# Supporting Content for Comment 317 SCMR Limit Adjustment

Authors: Jason Ellison, Howard Heck, Megha Shanbhag,  
Nathan Tracy

Table 179-14—Cable assembly characteristics summary

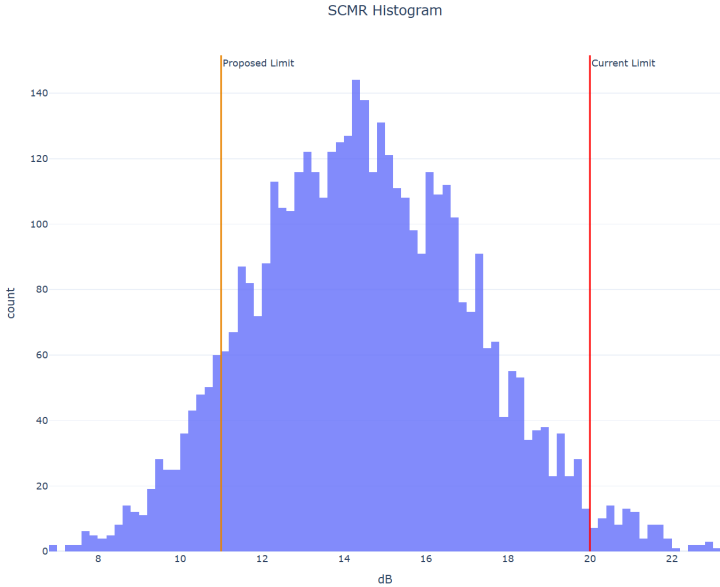
- **SCMR**, a new normative parameter 200GBASE-CR1, 400GBASE-CR2, and 800GBASE-CR4 devices, was introduced in D2.1.
- SCMR was extracted from 624 differential pairs from 39 cable assemblies. The total distribution of all SCMR metrics from all cables is shown to the right.
- This data is from cables that are operating successfully in the field.
- The failure rate was 96.3% with the current limit (only considering SCMR\_CH).

- Proposal: change the minimum SCMR from 20 dB to 11 dB
- Moving the value to 11 reduces the failure rate of production level components from 96.3% to 3.7%.

SCMR Correlation Heatmap

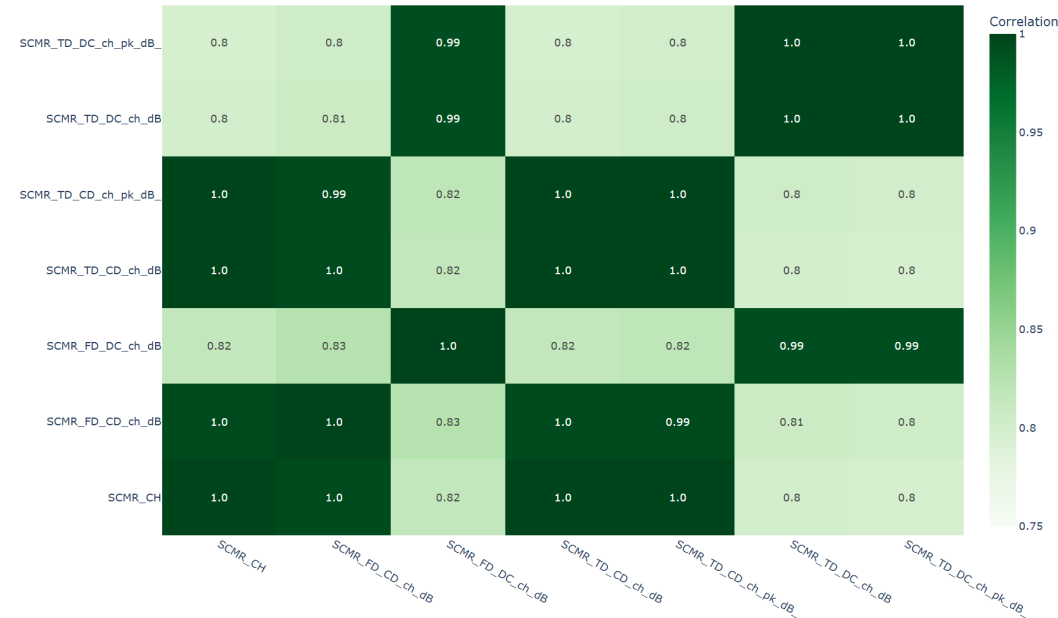
com\_ieee8023\_4p10\_SCMR.m was used to calculate SCMR and seven SCRM values area available for this analysis.

The SCMR values are all highly correlated.

For the proposed limit, SCMR\_CH was used as a representative estimate, as it appears to be less influenced by the extremes observed in the higher and lower trending results.
